GROUND FLOOR PLAN Extension as built 2017 (deemed Planning Consent granted)

48 Shaftesbury Road, Rustington: Regularisation of Construction to comply with Regulations

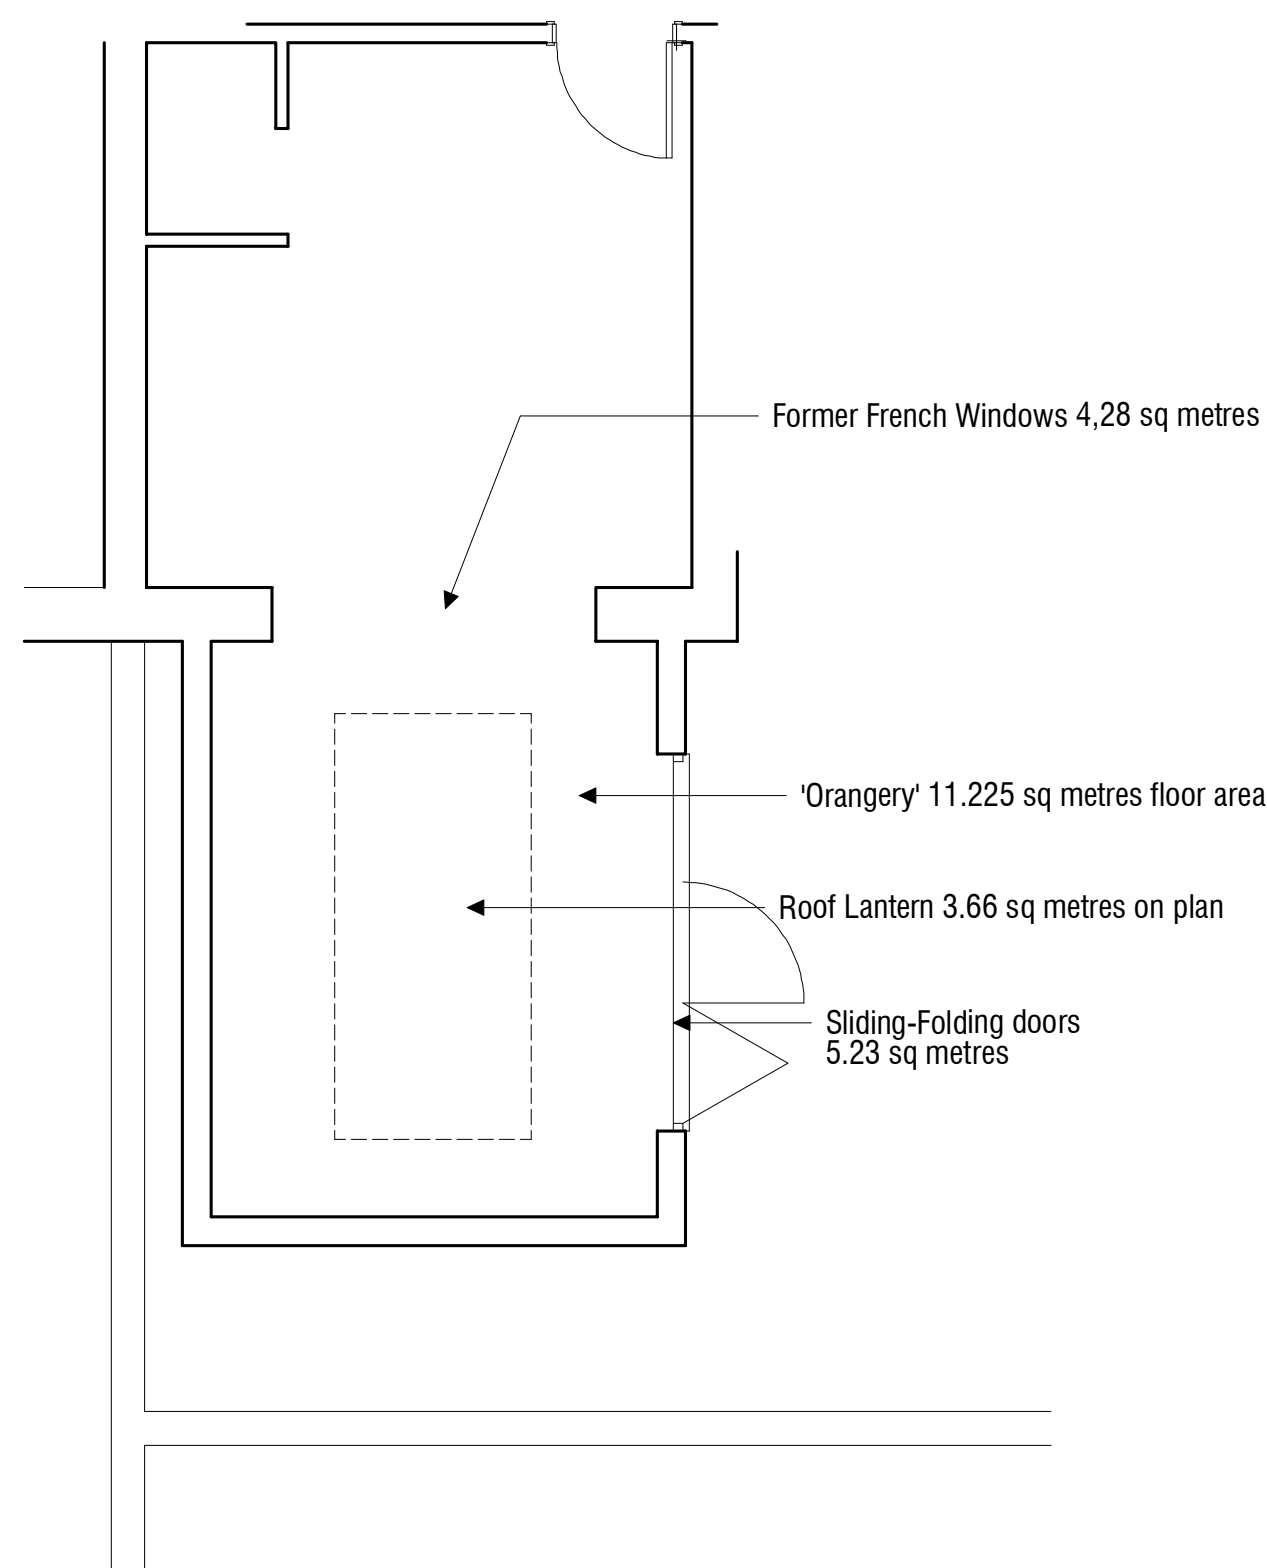
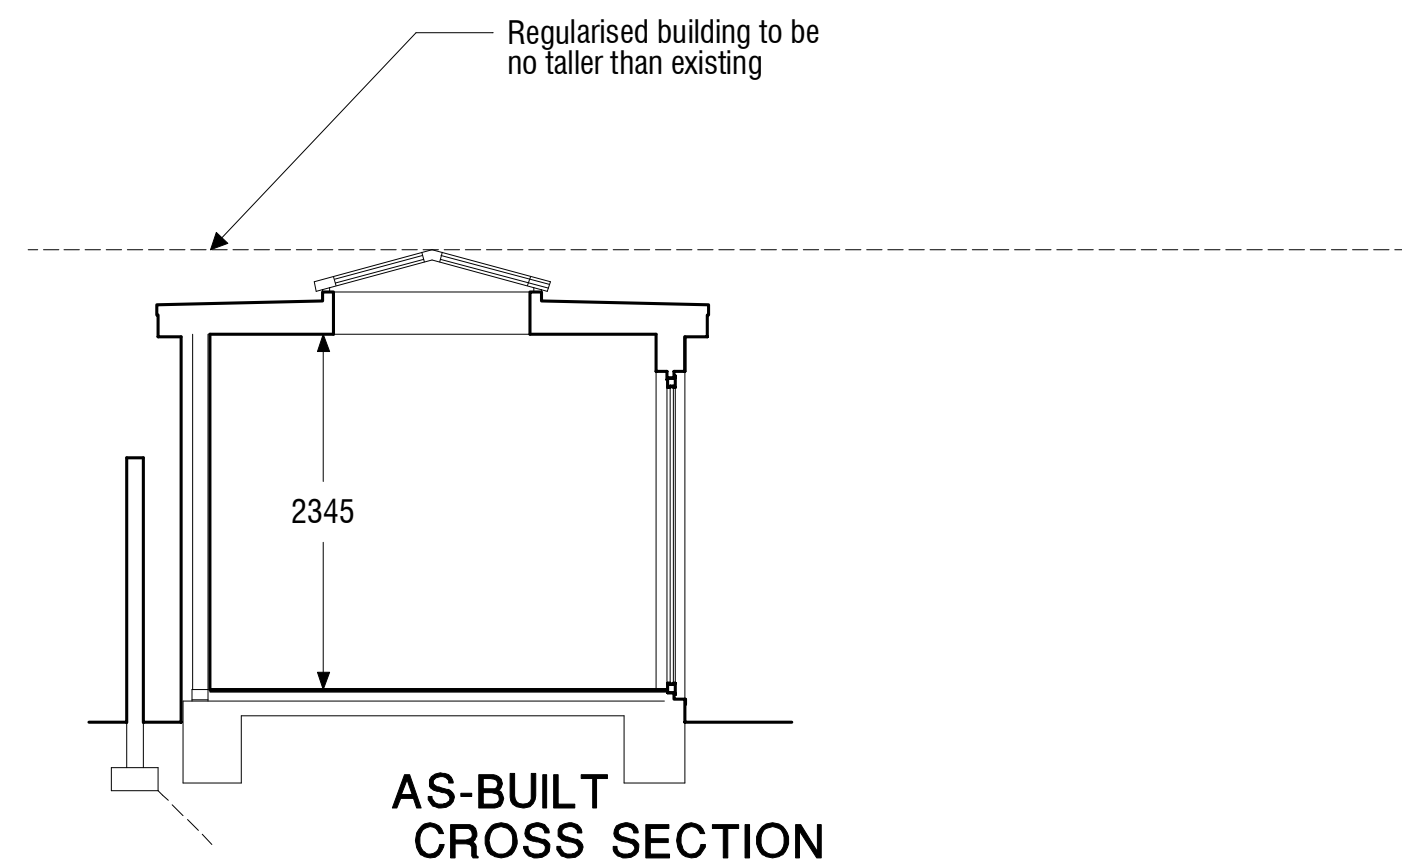
Permissible Glazed Area without compensating measures:
 $4.28 + (11.225 / 4) = 7.086$ sq metres

Glazing as installed = 8.91 sq metres

Reduction required = 1.82 sq metres
 e.g., reduce length of roof lantern by 1.39 metres

To be addressed:
 Foundations must comply with Regulations.
 Suitable-height upstand to be provided for Roof Lantern, normally 150mm.
 U-Value of Roof to be 0.18 or better
 U-Value of walls to be 0.28 or better
 U-Value of floor to be 0.22 or better
 Laminate flooring surface to be below top of door cill, and to be sealed.
 Amount of glazing to be reduced, or insulation to be improved (calculations would be required).
 Render not to bridge DPC.
 Trickle Ventilation to be provided.
 Ventilation likely to be required in wall (and roof if not warm-roof) construction to remove condensation

If existing roof light and S/F doors are re-used, then insulation will have to be increased (requires calculation) which may possibly be achievable by using thicker ceiling and wall insulated linings, but special nails / screws must be used, and the ceiling height and / or room width will reduce. Alternatively deeper joists and / or studs could be used with more insulation between, but this will also reduce the room size marginally.

or increase insulation to compensate

Available Options:
 Foundations:
 Either Conventional Mass Concrete Strip taking account of any trees
 or Reinforced Concrete Raft (requires Engineer's Design, but less digging)

Roof Insulation:
 Either Warm Roof with majority of Insulation above Joists, and some between (advantage: no ventilation required disadvantage: thicker construction, lower ceiling)
 Or 'Cold' roof with insulation at ceiling level (advantage: slightly thinner construction, but requires above-insulation ventilation and under-joist insulation, so ceiling height will be less than existing either way)
 Ceiling Height assumes overall height of building must not increase for Planning and Neighbour-Relations reasons.

Wall Insulation:
 U-Value of 0.18 can be achieved using either 100mm Mineral Fibre or 60mm Celotex, but in both cases a insulated inner lining is required (reducing room width by 50mm / 2 inches) and Mineral Fibre requires an additional unvented airspace increasing wall thickness by 50mm
 Manufacturer specifies ventilation between insulation and outer cladding / render.
 100mm studwork works with either scheme, but care needed to ensure insulation is not thicker than studs, or plasterboard is likely to pop off (so CLS may not be suitable)
 The advantage of Mineral Fibre is, apart from being cheaper, it keeps noise out better.

Floor Insulation:
 Perimeter / Area = $10.56 / 11.225$
 = 0.94. To provide U value of 0.22.
 80mm Celotex or 100mm expanded Polystyrene is required (underfloor ducts to be retained and kept operational to ventilate existing original floor voids)
